E/ECE/324
E/ECE/TRANS/505 Add.9/Rev.2/Amend.1

Addendum 9: Regulation No. 10

Revision 2 - Amendment 1

UNIFORM PROVISIONS CONCERNING THE APPROVAL OF VEHICLES WITH REGARD TO ELECTROMAGNETIC COMPATIBILITY

"Figure 2

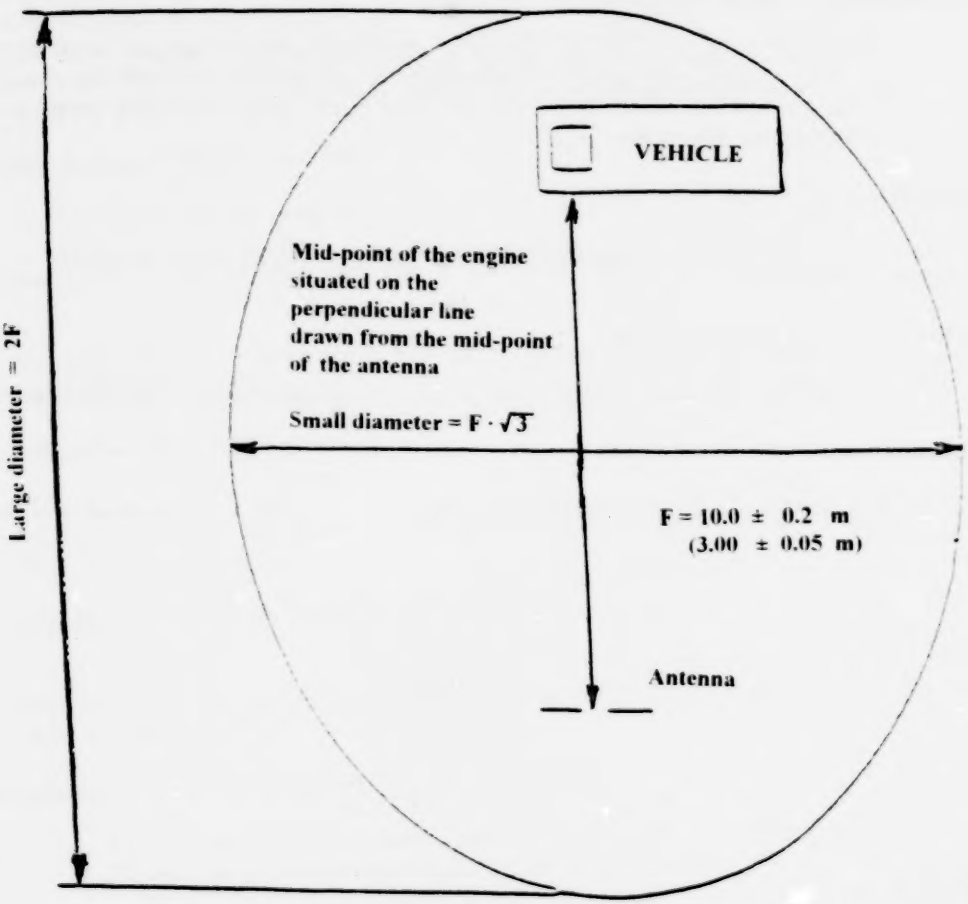
"... (see Fig. 1 of appendix 1 to this annex). Alternatively, for L-category vehicles the test surface may be any location that fulfils the conditions shown in Figure 2 of appendix 1 to this annex."

"... shown in Figure 1 in appendix 1 to this annex. Where test surface fulfils the conditions stated in Figure 2 in appendix 1 to this annex, the measuring equipment must lie outside the part shown in this Figure 2. Other measuring antennae ..."

Insert a new Figure 2, to read:

Clear horizontal surface free of electromagnetic reflection
Delimitation of the surface defined by an ellipse
(See CISPR 12, Edition 2)

VEHICLE
Mid-point of the engine situated on the perpendicular line drawn from the mid-point of the antenna
Small diameter = F · √3
Large diameter = 2F
F = 10.0 ± 0.2 m
(3.00 ± 0.05 m)
Antenna

"Figure 4

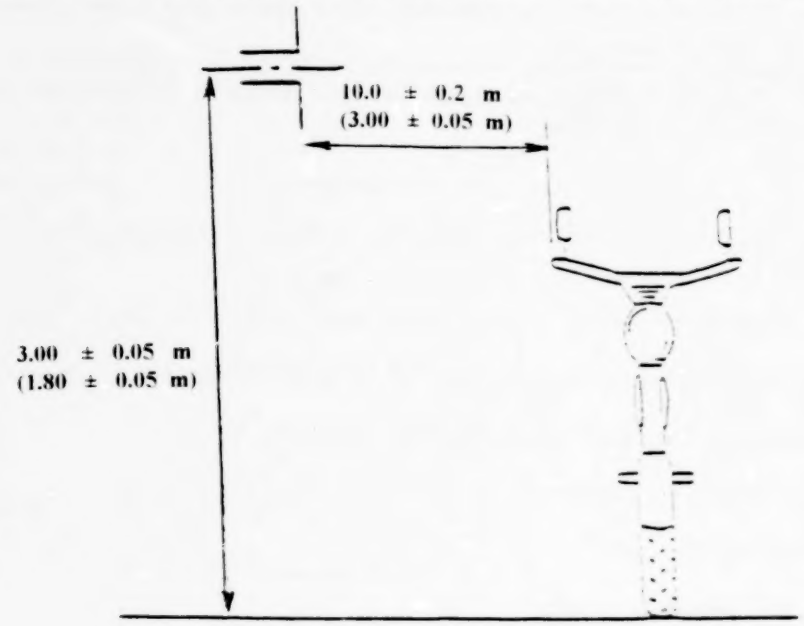
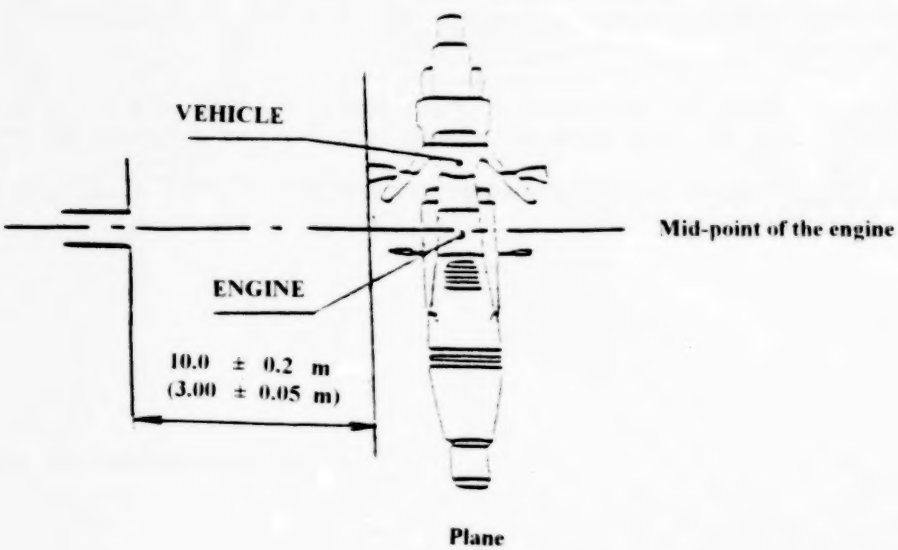
"... engine mid-point. (See Fig. 3 and 4 in appendix 1 to this annex)."

"... and vertical polarizations. (See Fig. 3 and 4 in appendix 1 to this annex.)"

Insert a new figure 4, to read:

Position of antenna in relation to the vehicle

Dipole antenna in position to measure the vertical radiation components

Dipole antenna in position to measure the horizontal radiation components "

"Annex 6 - Appendix 3

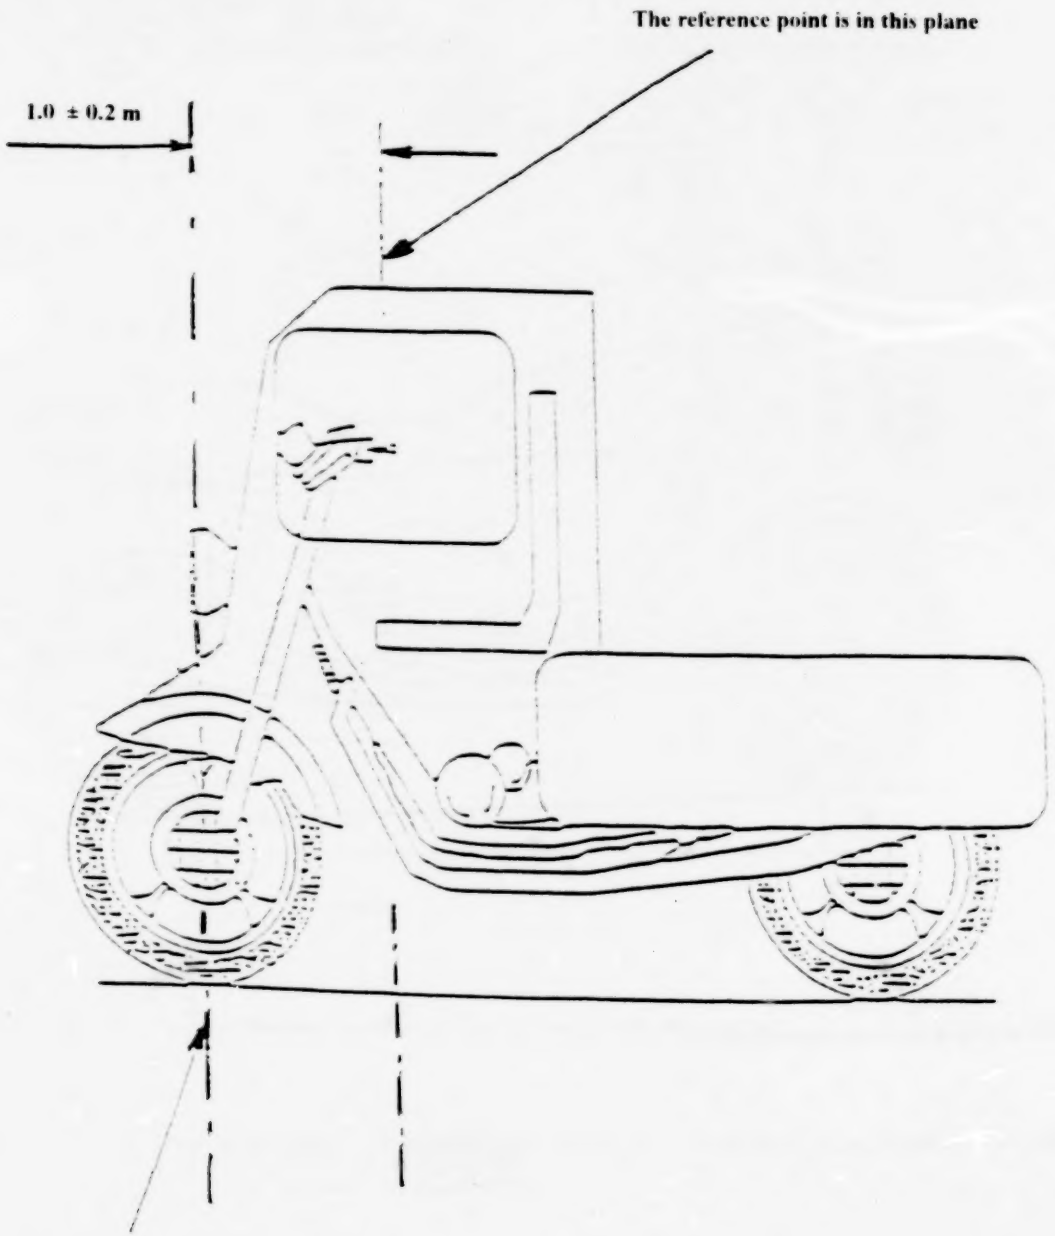
"... in a reference point closer to the antenna,
or:
at 1.0 ± 0.2 m behind the vertical centreline of the vehicle's front wheel (point C in appendix 3 to this annex) in the case of three-wheeled vehicles,
or:
at 0.2 ± 0.2 m behind the vertical centreline of the vehicle's front wheel (point D in appendix 4 to this annex) in the case of two-wheeled vehicles."

Insert new appendices 3 and 4 to annex 6, to read:

"Annex 6 - Appendix 6

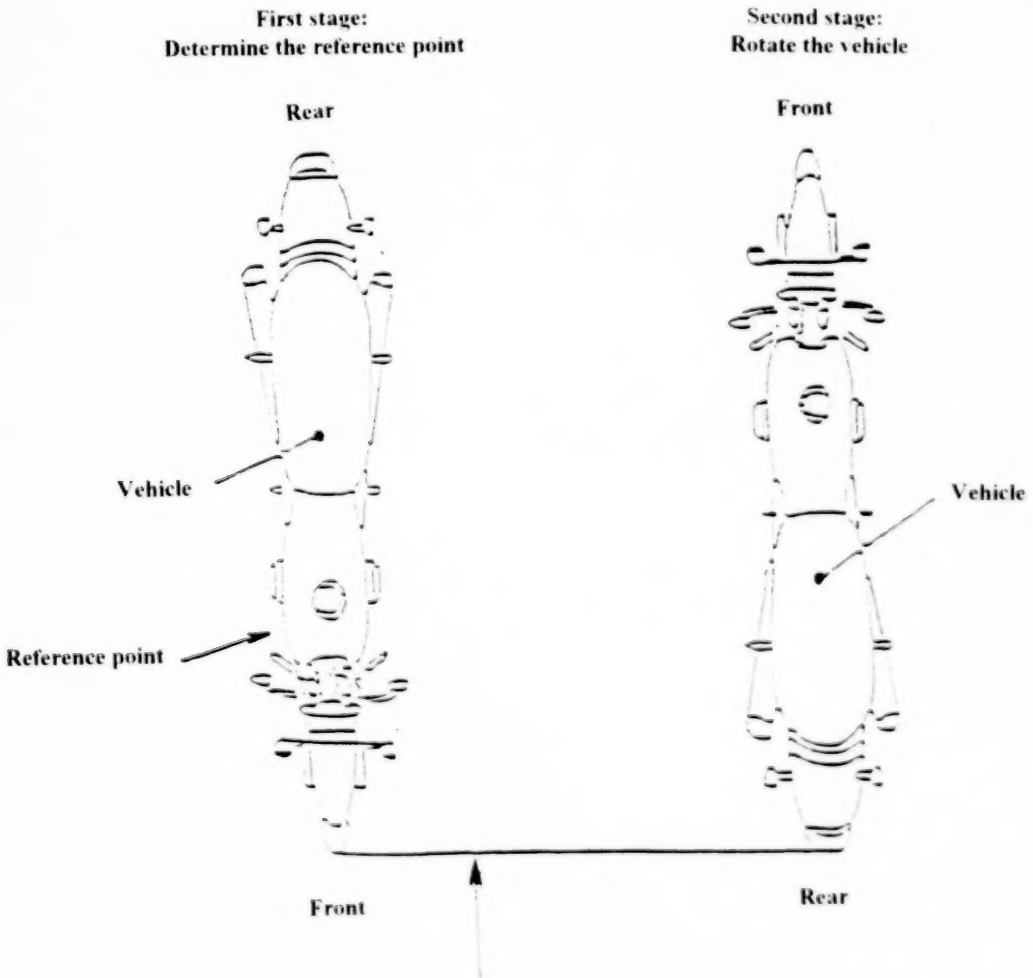
Paragraph 5.5., amend the reference to "appendix 3 to this annex" to read "appendices 5 and 6 to this annex as appropriate for the category of vehicle."

Insert a new Annex 6 - Appendix 6, to read:

Distance maintained between the vehicle and antenna
